Town of Franklin

Planning Board

September 28, 2020

DATE: September 23, 2020
TO: Franklin Planning Board
FROM: Department of Planning and Community Development
RE: Lakeview Terrace – Private Subdivision
Partial Form H

SITE DETAILS
C5.0
DWG. No. 6120-DET.DWG © 2020 INTERFORM ARCHITECTURE + DESIGN

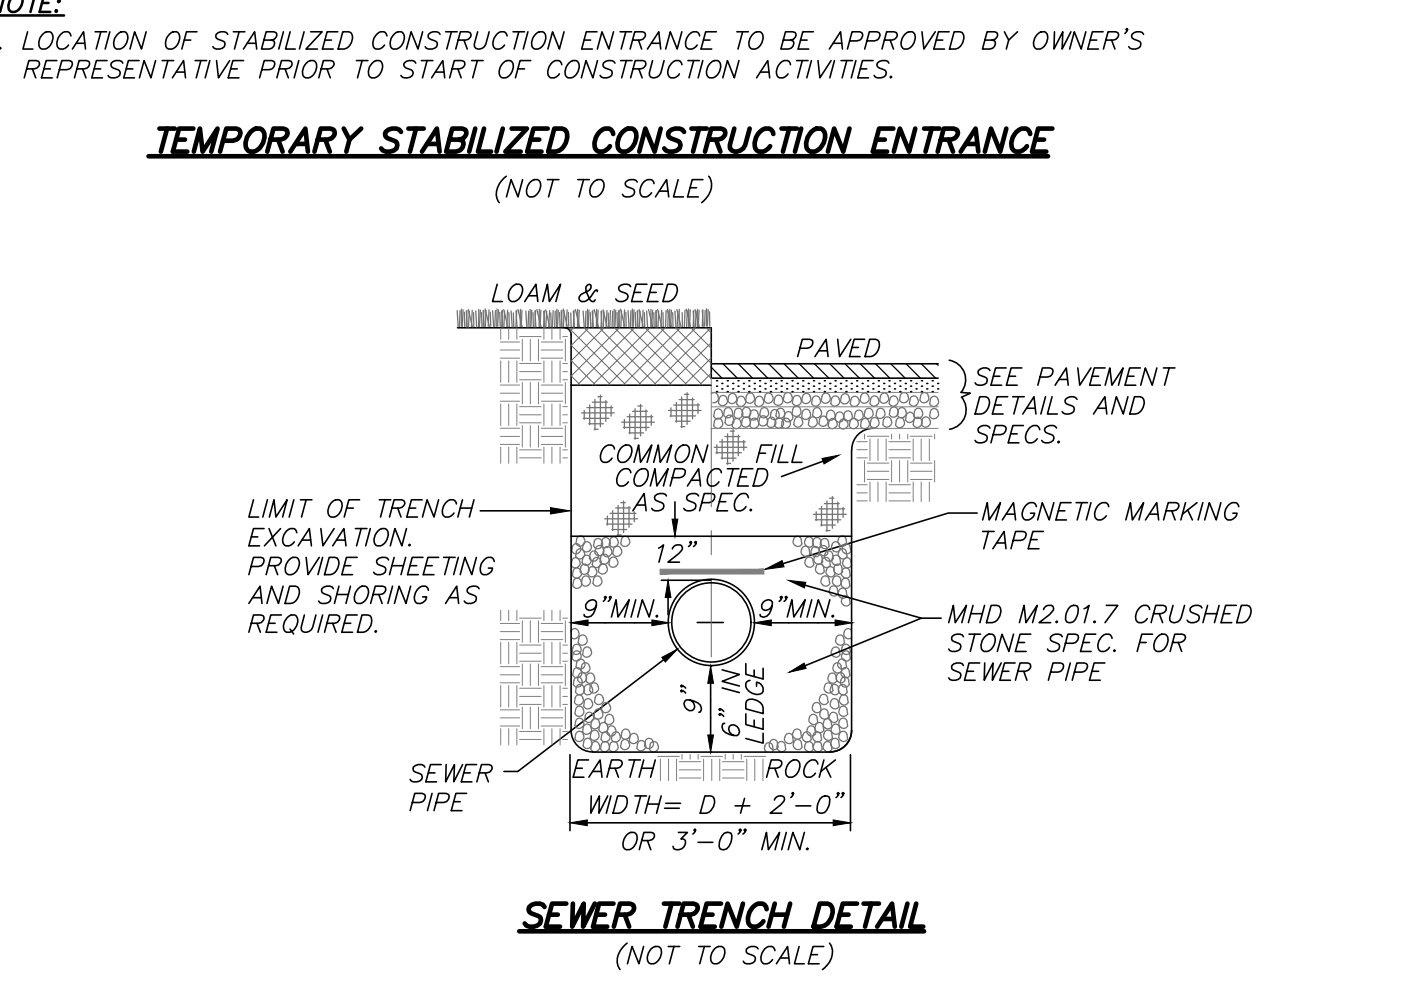
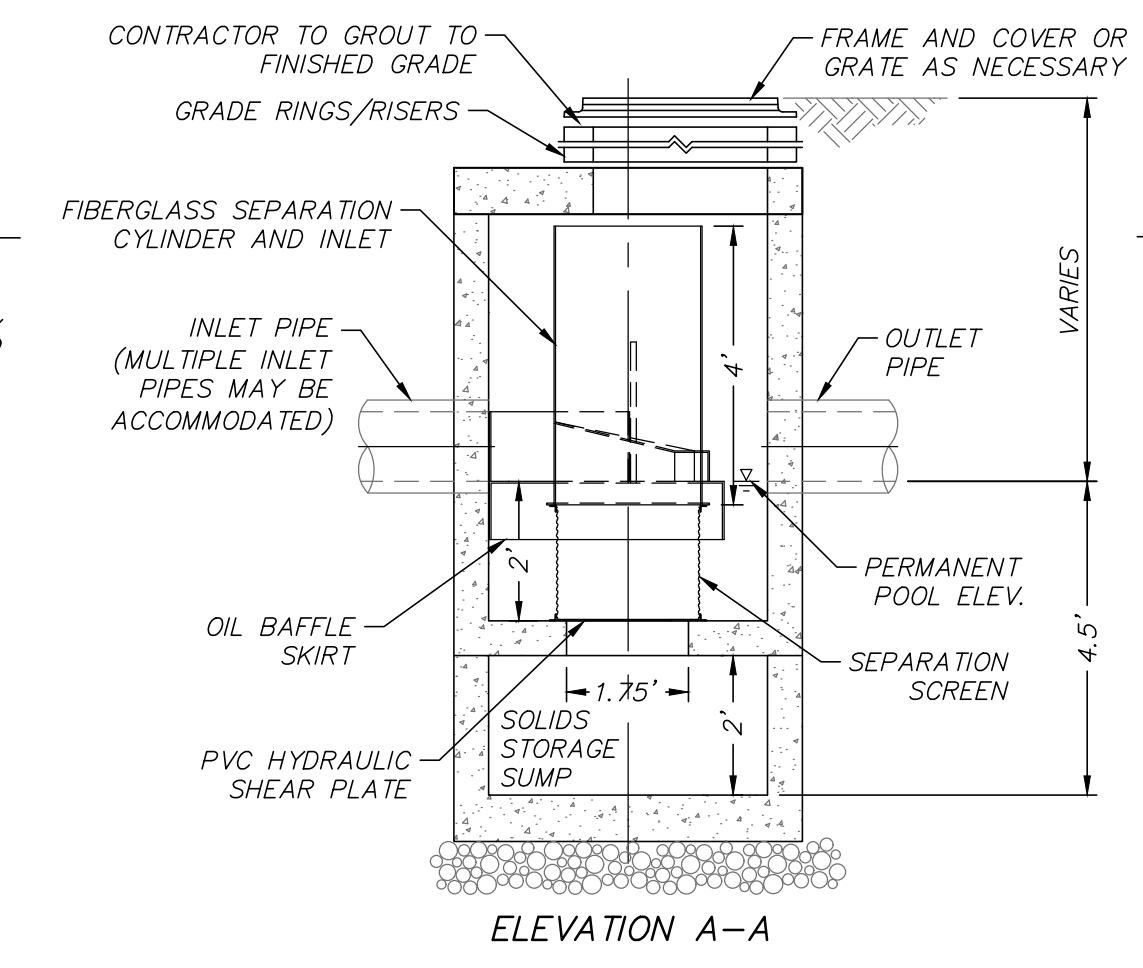
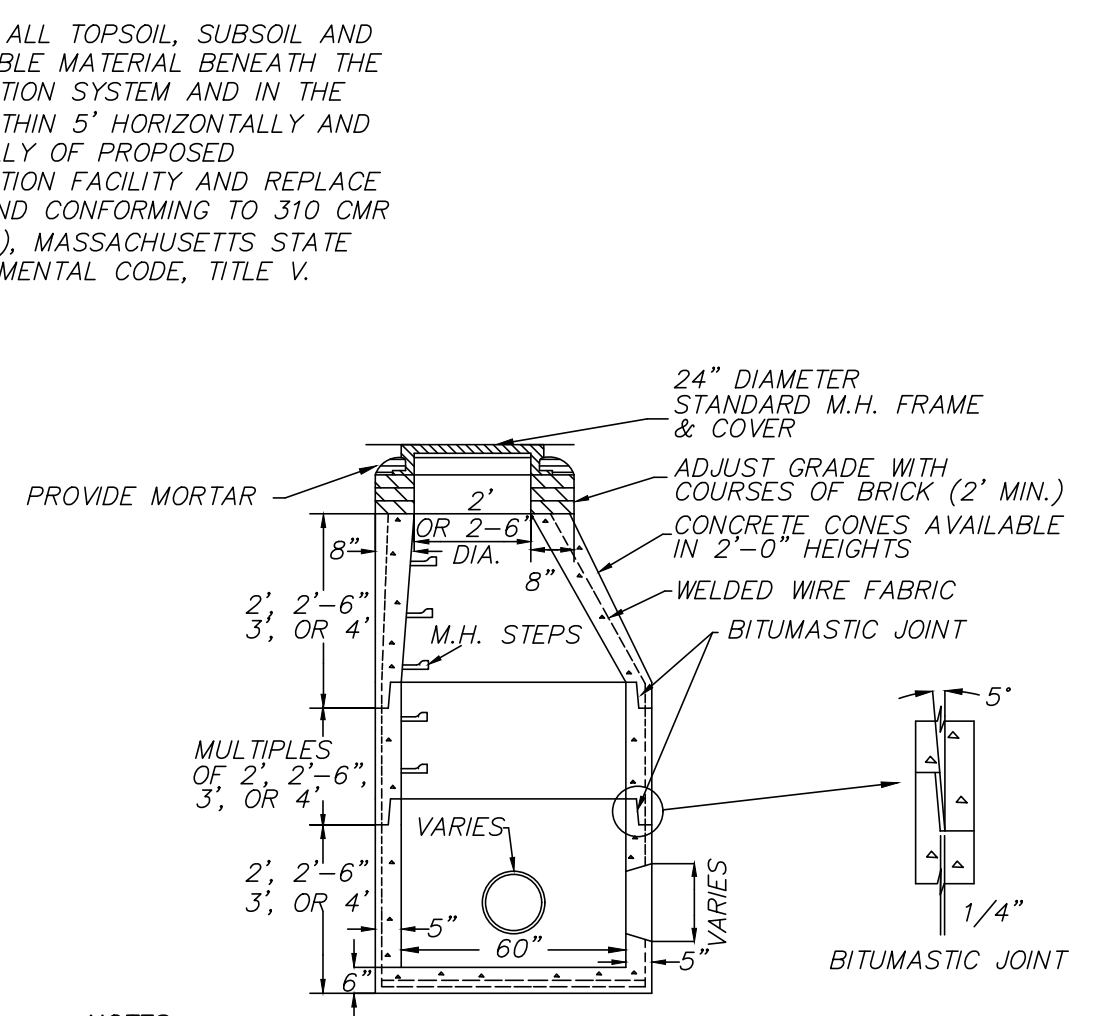
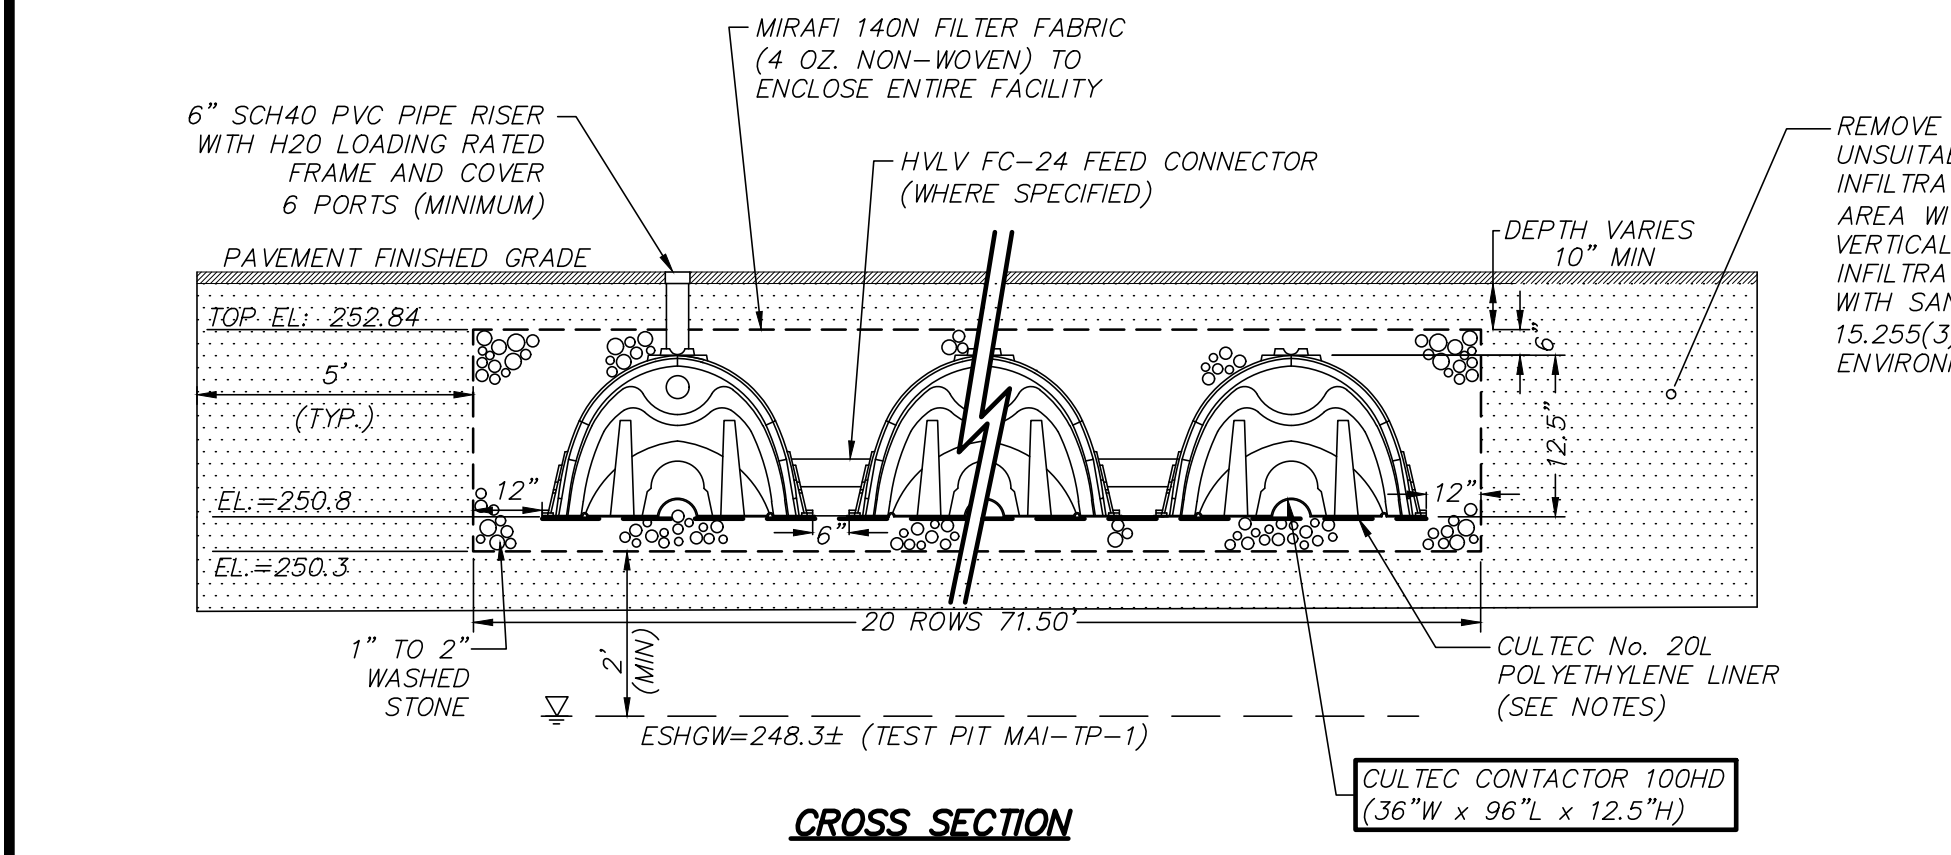
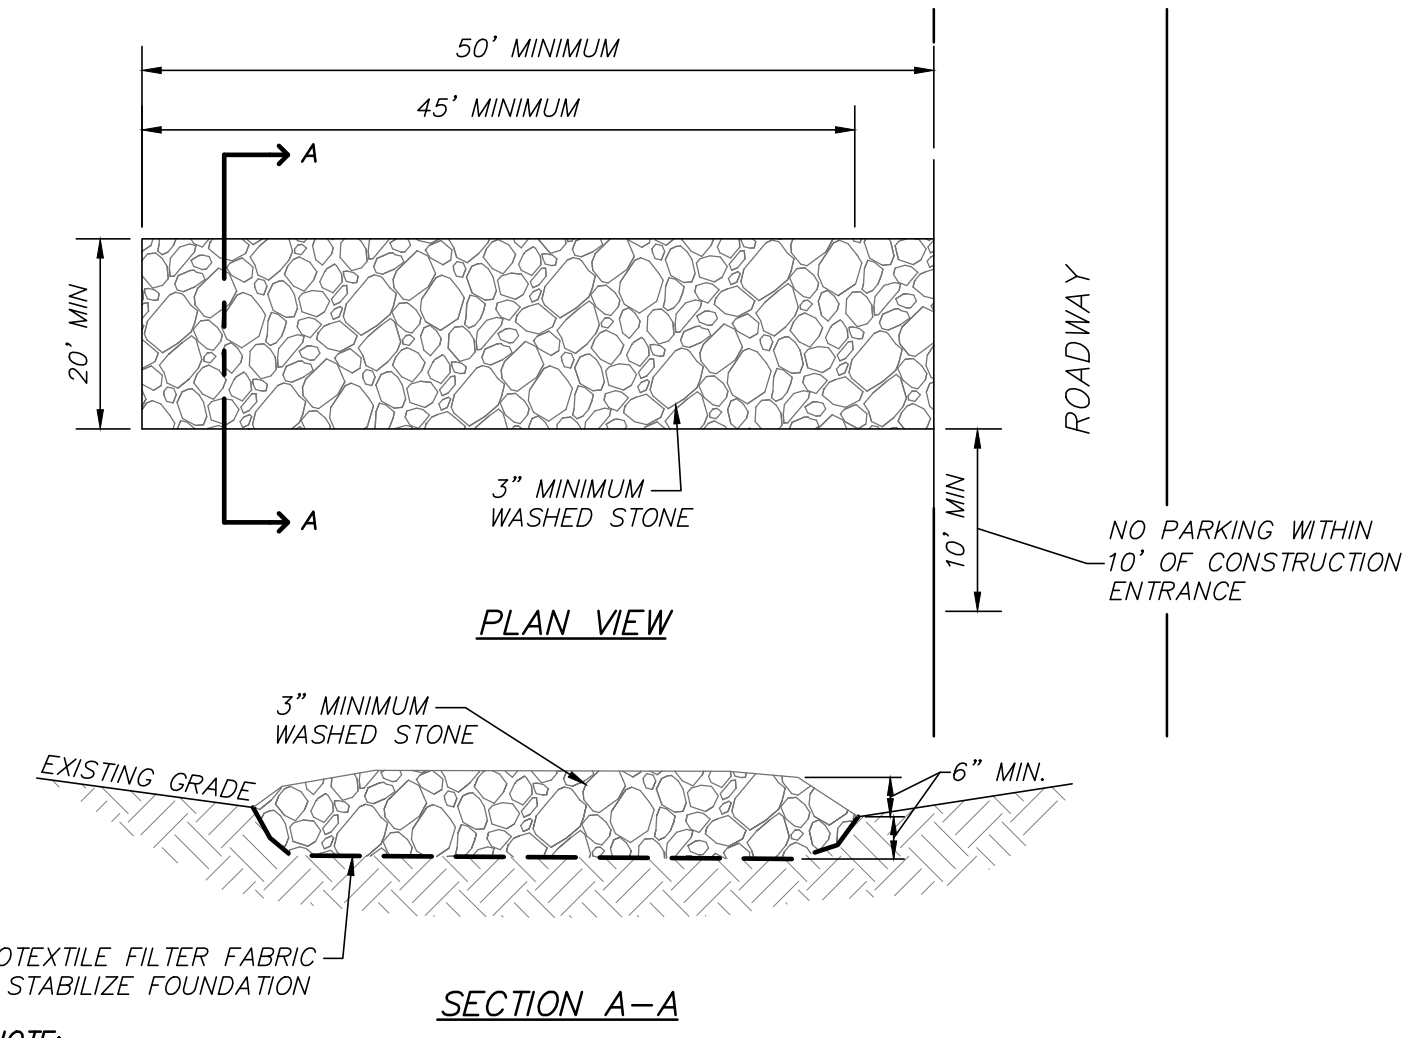
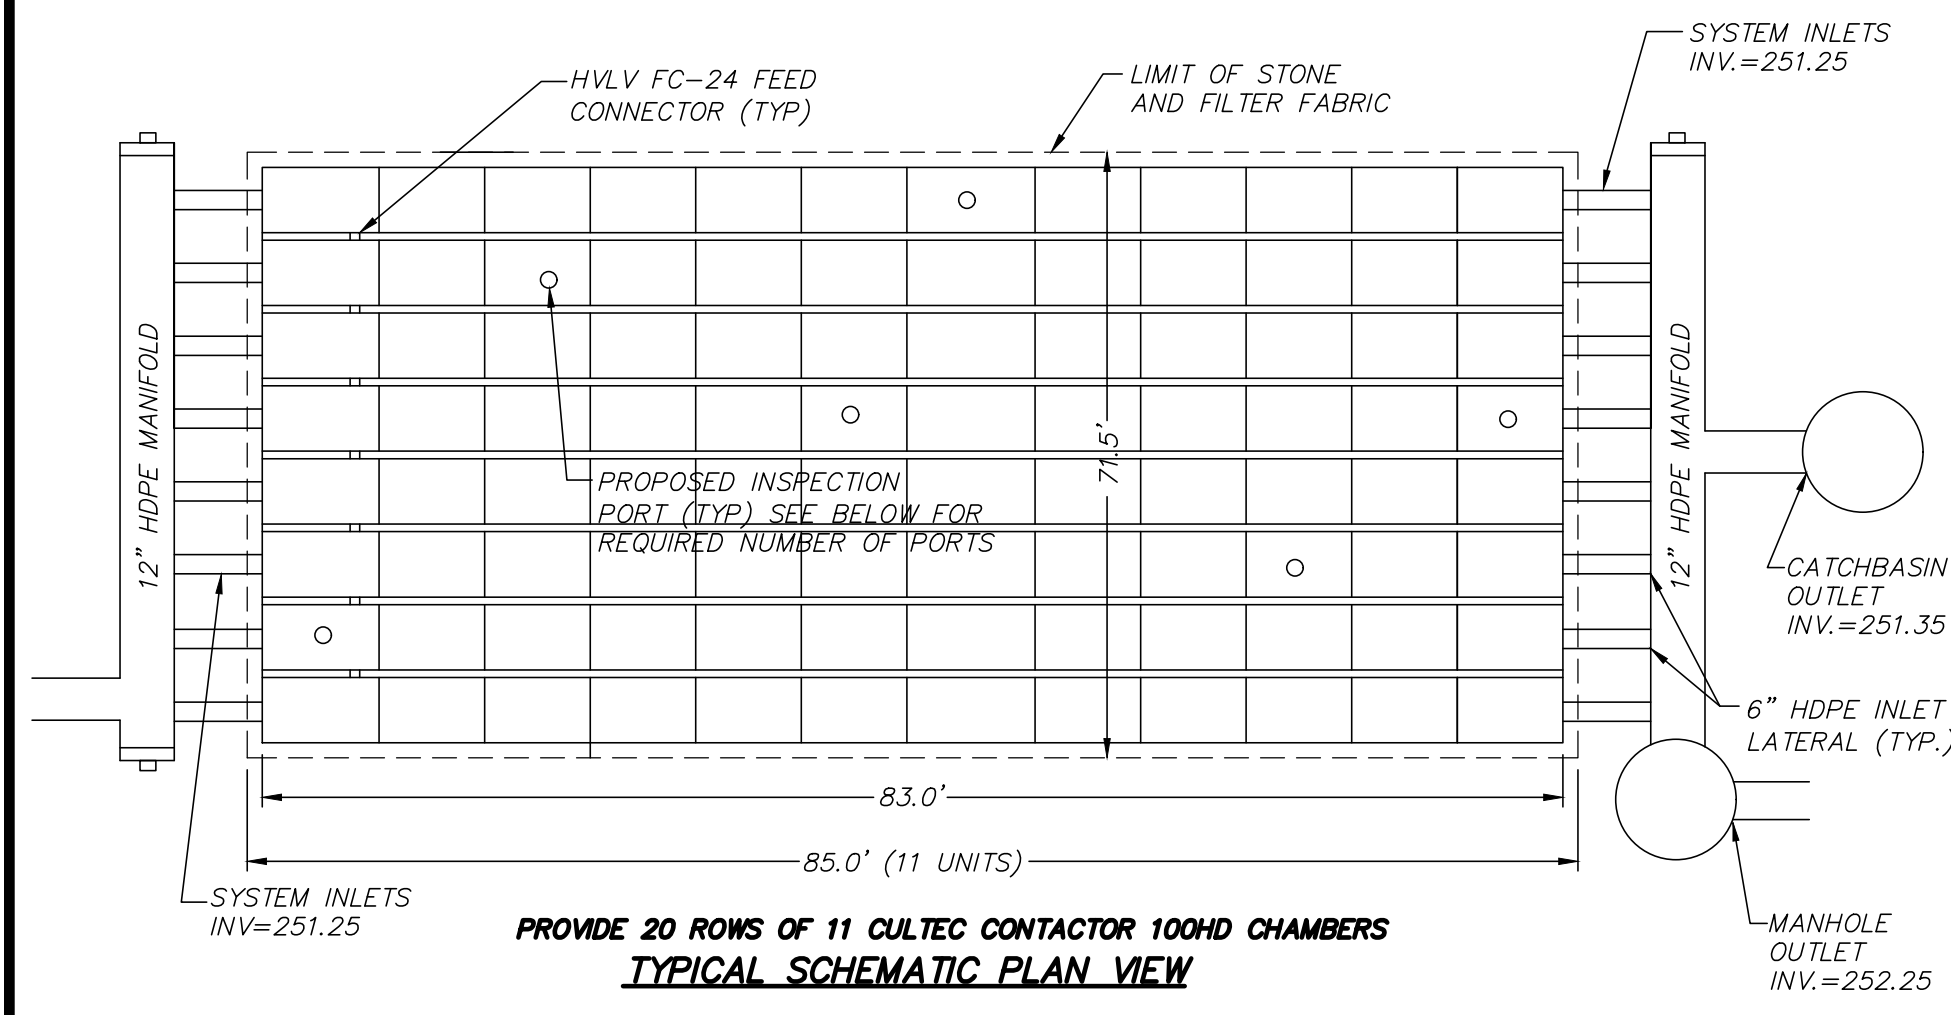
SW5. Revise the diameter of the proposed catch basins to a minimum of 5 feet to accommodate the proposed double grates. *MAI: The diameter of the catch basins have been revised accordingly, refer to Sheet C 5.0.* BETA2: Diameter revised – issue resolved.

SW16. Clarify the Schematic Plan View of the Subsurface Infiltration Facility Details to indicate it is a typical layout and the dimensions are 20 rows of 11 chambers. Revise detail name, as necessary, to reflect the number of systems proposed. *MAI: The details of the Subsurface Infiltration Facility details have been revised accordingly, refer to Sheet C 5.0.* BETA2: Details revised – issue resolved.

SW18. Revise the top elevation of the stone in the infiltration system on the Cross Section detail to be consistent with other elevations. *MAI: The top elevation of the stone in the infiltration system has been revised accordingly, refer to Sheet C 5.0.* BETA2: Elevation revised – issue resolved.

- SW5. Revise the diameter of the proposed catch basins to a minimum of 5 feet to accommodate the proposed double grates. *MAI: The diameter of the catch basins have been revised accordingly, refer to Sheet C 5.0. BETA2: Diameter revised – issue resolved.*
- SW6. Consider providing periodic check dams in the northerly swale to minimize flow velocities and promote infiltration. *MAI: Check dams have been added to the plan set, refer to Sheet C 2.0. BETA2: Check dams provided – issue resolved.*
- SW7. Clarify where the Typical Level Spreader is proposed. *MAI: The location of the level spreader has been added to the plan set, refer to Sheet 2.0. BETA2: Clarification provided – issue resolved.*
- SW7A. Revise the infiltration system overflow size on the plan from 4” to 6” to match the current HydroCAD model.**

- SW16. Clarify the Schematic Plan View of the Subsurface Infiltration Facility Details to indicate it is a typical layout and the dimensions are 20 rows of 11 chambers. Revise detail name, as necessary, to reflect the number of systems proposed. *MAI: The details of the Subsurface Infiltration Facility details have been revised accordingly, refer to Sheet C 5.0. BETA2: Details revised – issue resolved.*

- SW18. Revise the top elevation of the stone in the infiltration system on the Cross Section detail to be consistent with other elevations. *MAI: The top elevation of the stone in the infiltration system has been revised accordingly, refer to Sheet C 5.0. BETA2: Elevation revised – issue resolved.*
